SERVICE BULLETIN

No. 565

Piper Aircraft Corporation

Edo Aire Mitchell Service Bulletin No. MB-13, dated May 3, 1977; Modification to Edo Aire Mitchell NSD-360 Horizontal Situation Indicator.

SKETCH A

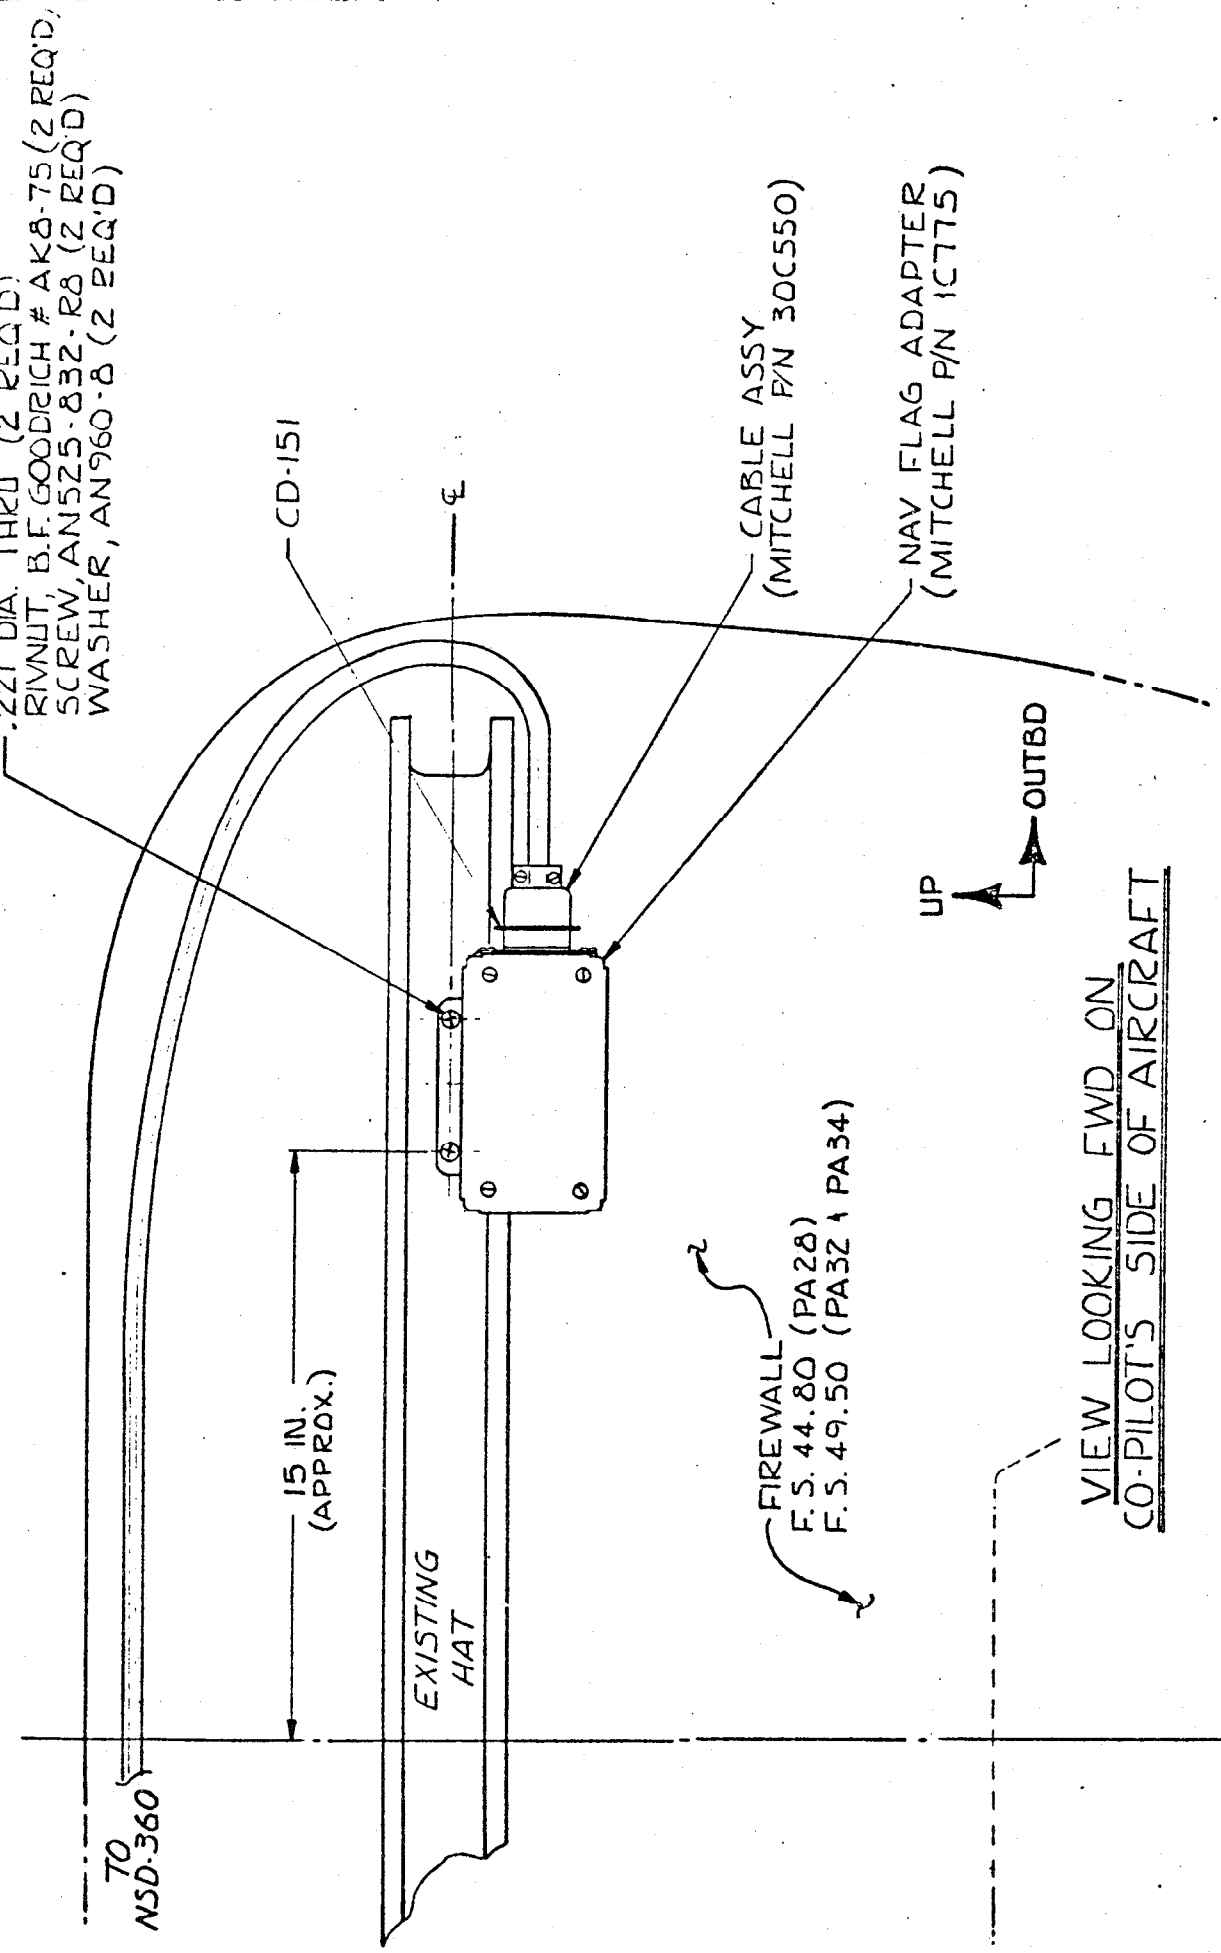
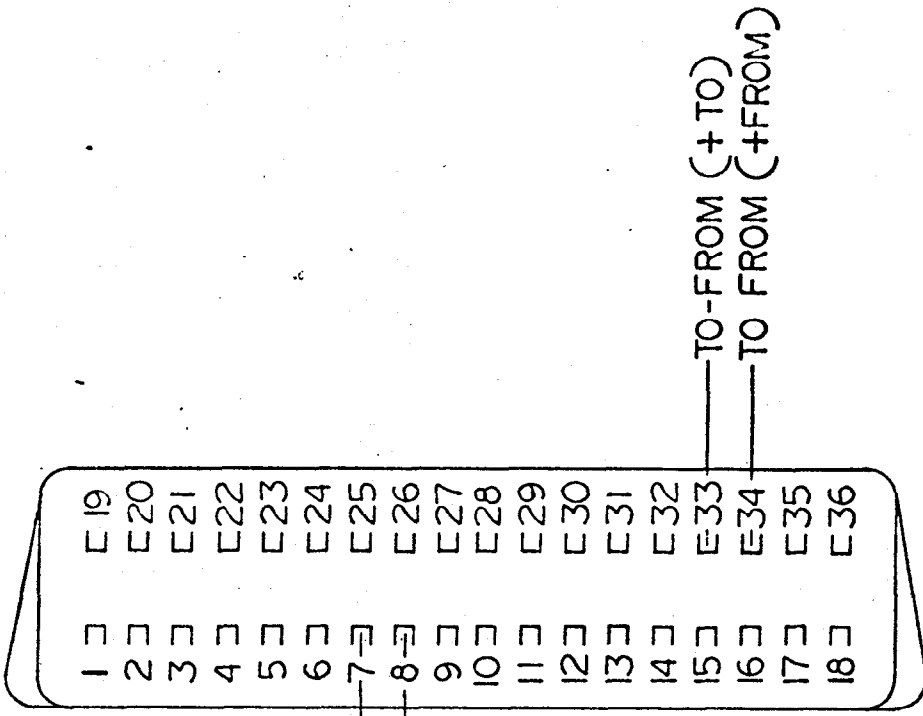
1. Remove the pilot and copilot seats from the aircraft.
2. Refer to Sketch "A" of this Service Bulletin for detailed installation instruction of the Nav Flag Adapter (Mitchell Part Number 1C775).
3. Refer to Sketch "B" of this Service Bulletin for all references to "View A-A" and general location information.

.221 DIA. THRU (2 REQ'D)
RIVNUT, B.F. GOODRICH # AK8-75 (2 REQ'D)
SCREW, AN525-832-R8 (2 REQ'D)
WASHER, AN960-8 (2 REQ'D)

NAV FLAG ADAPTER
(MITCHELL P/N 1C775)

FIREWALL
F.S. 44.80 (PA28)
F.S. 49.50 (PA32 + PA34)

SKETCH B

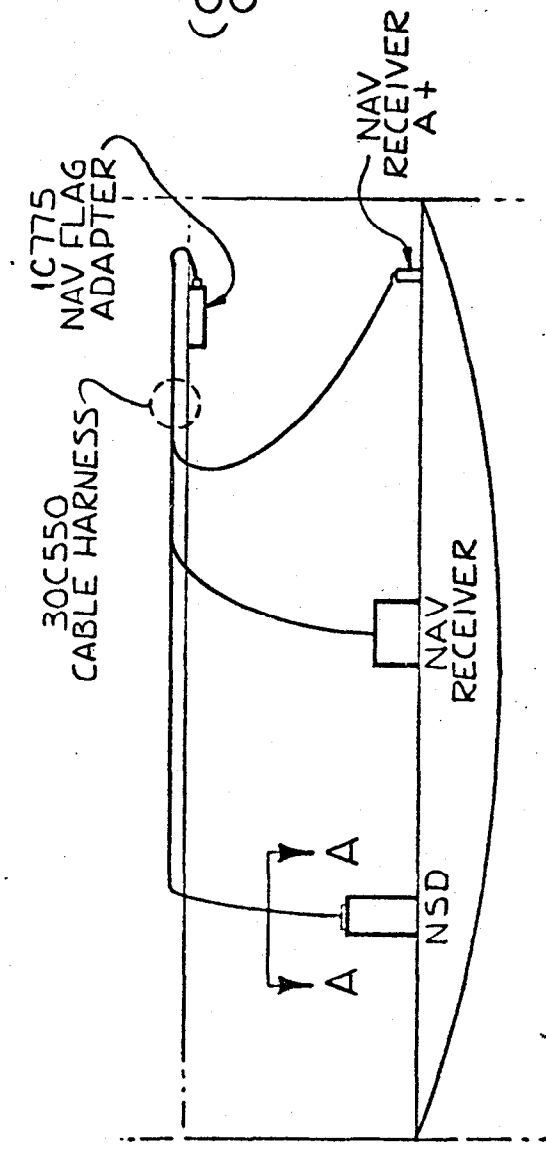
- b. Locate the wire routed from pin seven (7) of CD-106, (refer to View A-A) and cut this wire approximately six (6) inches from the plug. Locate the WHT/VIOLET wire in the 30C550 cable harness and attach it to the six (6) inch wire leading from pin seven (7) of CD-106. Use the 29559 butt splice to make all connections.

- c. Locate the WHT/BLK/VIOLET wire in the 30C550 cable and attach it to the other half of the wire that was attached to pin seven (7) in "b", above.
 - d. Locate the wire routed from pin eight (8) at CD-106, and cut this wire approximately six (6) inches from the plug. Locate the WHT/GRY wire in the 30C550 cable and attach it to the six (6) inch wire leading from pin eight (8).

- e. Locate the WHT/BLK/GRY wire in the 30C550 cable and connect it to the other half of the wire that was attached to pin eight (8) in "d", above.
 - f. Locate the wire routed from pin 33 of CD-106, and cut this wire approximately six (6) inches from plug CD-106. Locate the WHT/ORG wire in the 30C550 cable and attach it to the six (6) inch wire leading from pin 33.

- g. Locate the WHT/BLK/ORG wire in the 30C550 cable and connect it to the other half of the wire that was attached to pin 33 in "f", above.
 - h. Locate the wire routed from pin 34 of CD-106, and cut this wire approximately six (6) inches from the plug. Locate the WHT/YEL wire coming from the 30C550 cable and attach it to the six (6) inch wire leading from pin 34.

VIEW A-A
(CD-106 WITH PLUG COVER REMOVED)

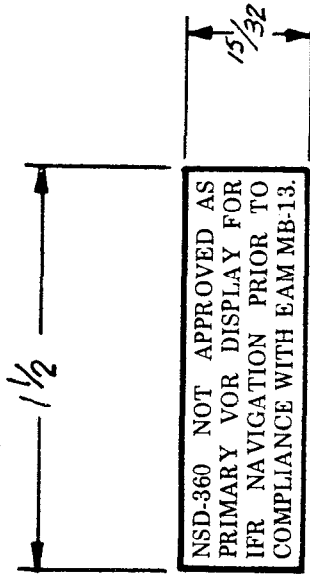
For the affected aircraft, Placard, P/N 13A895, must be installed on the instrument panel, as close as practical to the NSD-360 Navigation Instrument, prior to any further I.F.R. flight, or until the restriction is removed by installation of the NAV Flag Adapter, P/N 1C775.

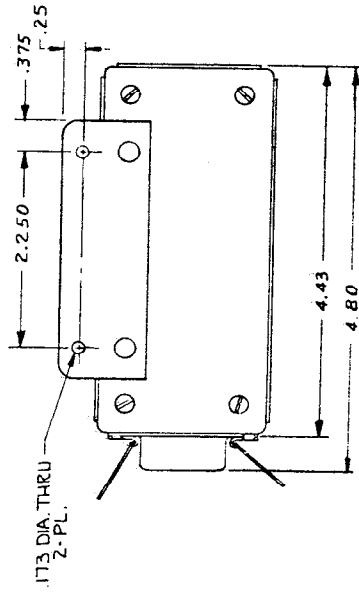
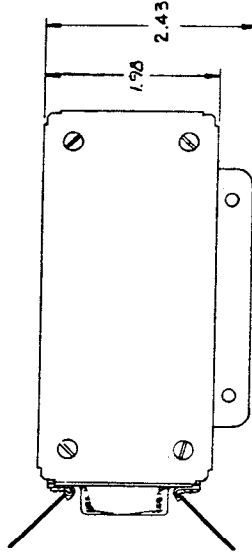
2. Using Drawing No. 1C775 as a guide, locate an area with sufficient space and structure to support the NAV Flag Adapter, and mark and drill two .173 dia. (No. 17 drill) holes.

EDO-AIRE MITCHELL MINERAL WELLS, TEXAS		
DATE: 1/15/77	REV: 1	DWG NO: 63D337-2
REVISED PER E.O. 12812	DATE: 1-23-77	REV: D
APPROVED: 1-20-77	DATE: 1-20-77	REV: ~
INTERCONNECT NSD-360 WITH VARIOUS VOR/LOC CONVERTERS & IC775 NAV FLAG ADAPTER		
APPLICATION		
TEST ASSEMBLY	USED ON	UNIT
FINISH	DATE	NO.

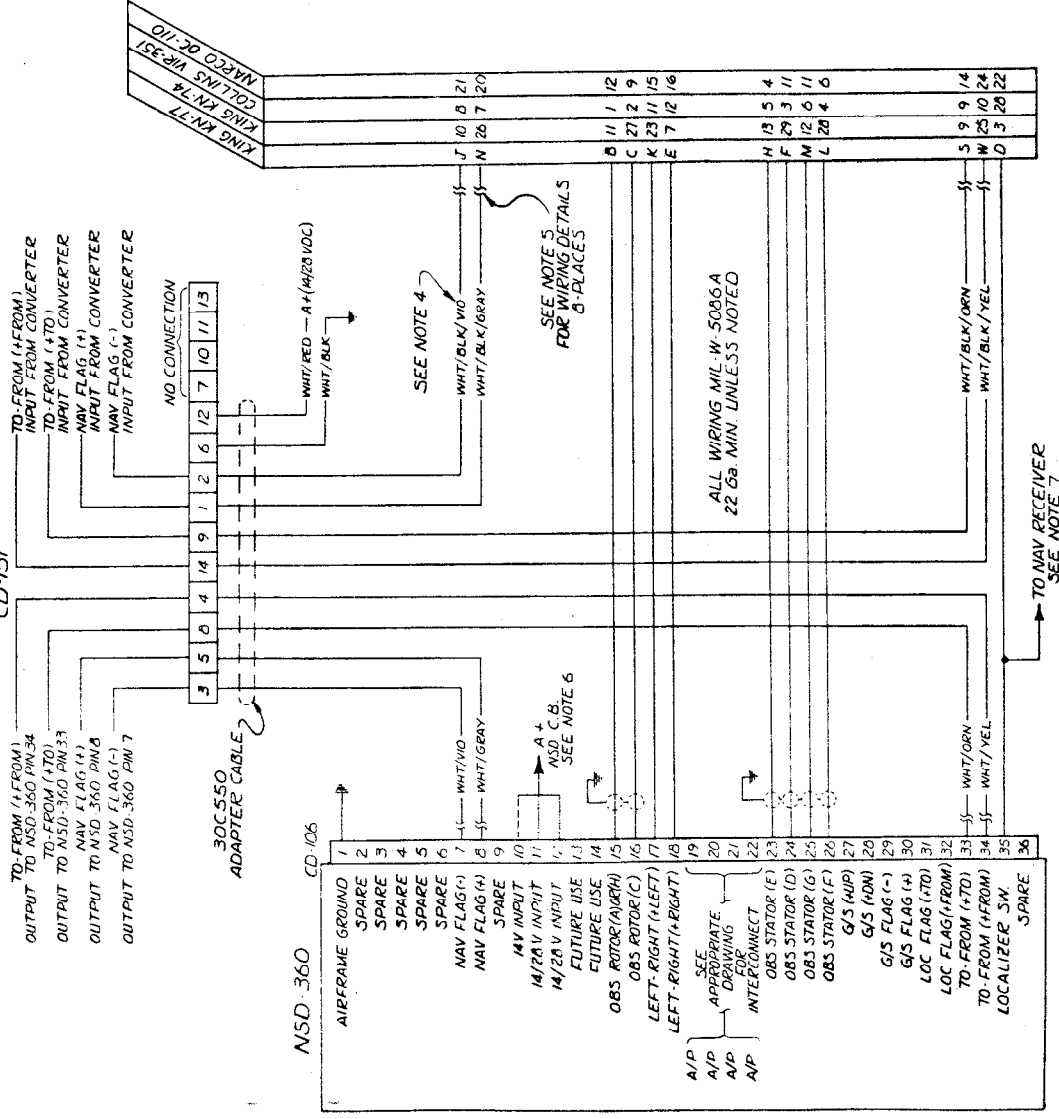
4. Wiring Instructions: (Refer to Drawing 63D337-2, on Page eight (8) of MB-13 for a pictorial representation of the following instructions).
 - a. Disconnect plug CD-106 from rear of the NSD-360 unit and remove all necessary cable restraints for approximately eight (8) inches to obtain sufficient cable freedom.

3. Secure the unit to the aircraft structure, using two each of the 8-32 screws, washers, and nuts supplied with PKMB-13.
4. Drawing No. 63D337-2 shows the interconnect wiring between the NSD-360 navigation instrument and the 1C775 NAV Flag Adapter. The four wires indicated, which are a part of the cable bundle to CD-106 of the NSD-360, are to be intercepted as close as feasible to CD-106, and the leads of Adapter Cable, P/N 30C550, are to be connected as shown on Drawing No. 63D337-2. Plug the CD-151 Plug of the 30C550 Cable into the CD-151 Receptacle of the 1C775 NAV Flag Adapter. Route the cable to CD-106 of the NSD-360, leaving sufficient service loop to adequately secure the cable. Cut the wire leads to the proper length and connect to the NSD-360 cable leads as shown using eight 29S59 butt splices. The ground lead of the 30C550 Cable should be routed to a convenient airframe ground. The A+ lead should be connected to the circuit breaker of the navigation receiver that is associated with the NSD-360. Do not connect the A+ to the NSD-360 circuit breaker!

- NOTES FOR INSTALLATION OF VARIOUS NSD-360'S & IC775 NAV FLAG ADAPTER WITH VARIOUS VOR/LOC CONVERTERS:**
- THIS DRAWING IS USED WHEN THE NSD-360 COMPASS SYSTEM IS USED WITH CONVERTERS OTHER THAN THE EDO-AIRE MITCHELL OMNI CONVERTER, PAI/CODT THESE INSTALLATIONS REQUIRE THE IC775 NAV FLAG ADAPTER BETWEEN THE NSD-360 AND CONVERTER AS SHOWN.

- REFER TO CONVERTER MFGS. INSTRUCTIONS FOR ADDITIONAL WIRING REQUIREMENTS.
 - WIRE COLOR CODES SHOWN REFER TO 30C550 ADAPTER CABLE.
 - REFER TO SERVICE BULLETIN MB-13 OR TO NSD-360 BULLETIN NO'S 479, 600 OR 668 FOR ADDITIONAL WIRING REQUIREMENTS AND INSTALLATION INSTRUCTIONS.
